# Wild Horse Wind Power Expansion Project

Final Supplemental Environmental Impact Statement

**Final Supplemental Environmental Impact  
Statement (SEIS)**

## 4 COMMENTS ON DRAFT SEIS AND RESPONSES

**Figure 3 - Expansion Features  
Wild Horse Supplemental EIS**

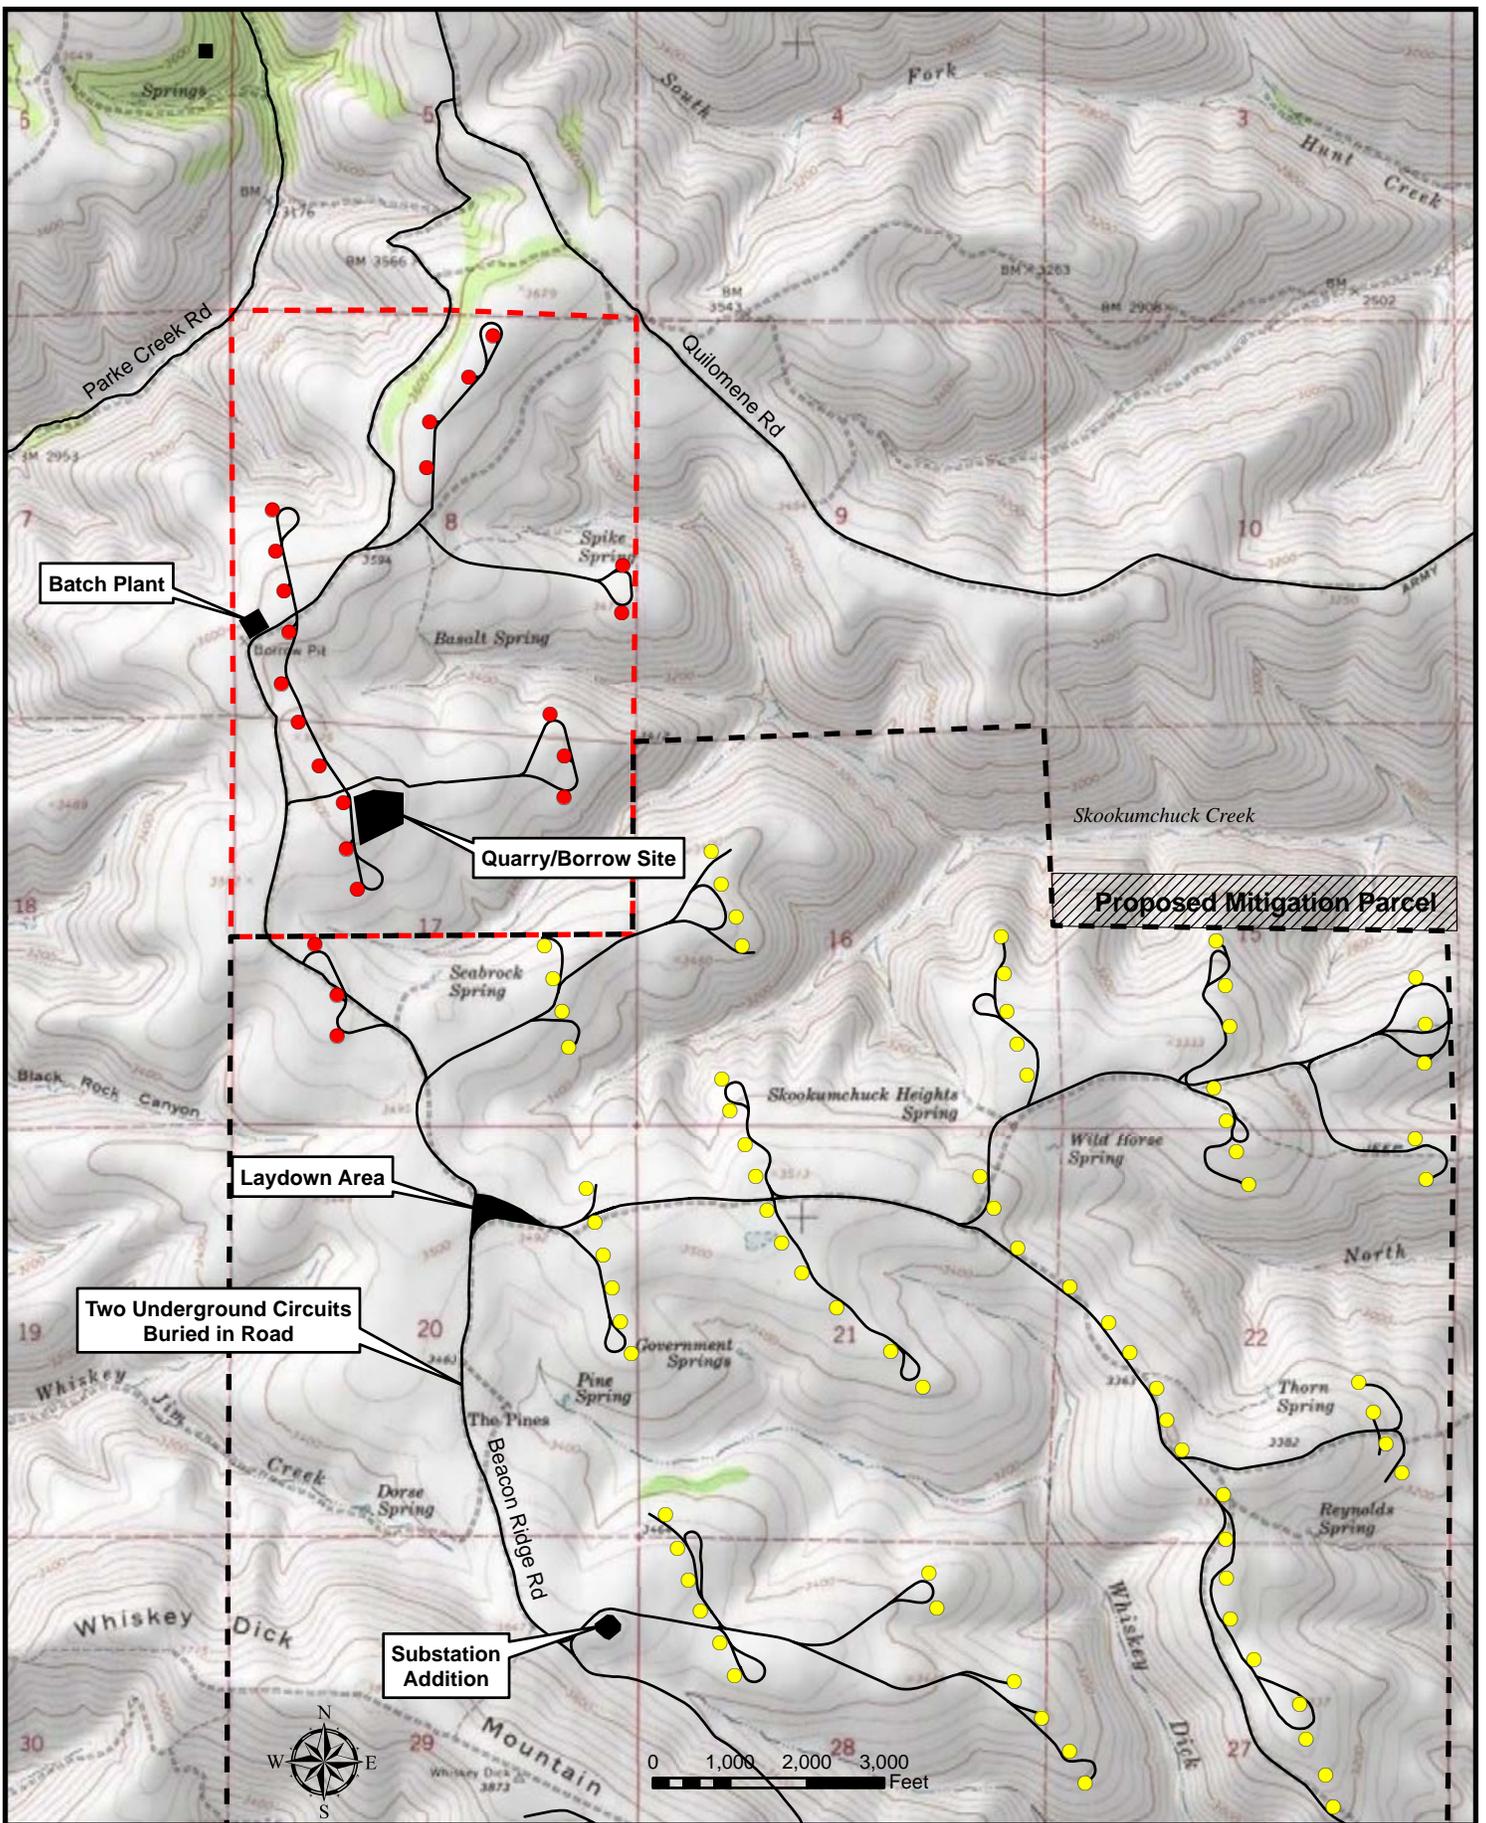
One comment requested a map and additional information about the habitat condition of the proposed mitigation parcel. A map is provided in Chapter 2. The mitigation parcel is an approximately 80-acre rectangle immediately adjacent to the northeast corner of the existing wind power facility (**Figure 3**). It is in the same basin, Skookumchuck Creek, as the majority of the expansion area. Located on a north-facing slope south of Skookumchuck Creek, elevation of the mitigation parcel varies between 2800 and 3200 feet. Habitat types are similar to those found in the expansion area, with a combination of mixed scrub, shrub-steppe, and bare rock habitats. Several of the draws on the mitigation parcel support relatively dense stands of sagebrush and other shrub species, with rocky and more open habitats on the ridge tops. Habitat condition in the mitigation parcel is generally less disturbed than in the expansion area, with no roads and less human disturbance. There are no documented springs on the mitigation parcel.

- 8-3. Thank you for your comment.
- 8-4. Location of the proposed 80-acre mitigation parcel is provided on a revised version of **Figure 3** in Chapter 2 of this Final SEIS. If the proposed parcel is not acceptable to WDFW, the applicant has proposed to mitigate per the alternative mitigation section in the 2003 WDFW Wind Power Guidelines.
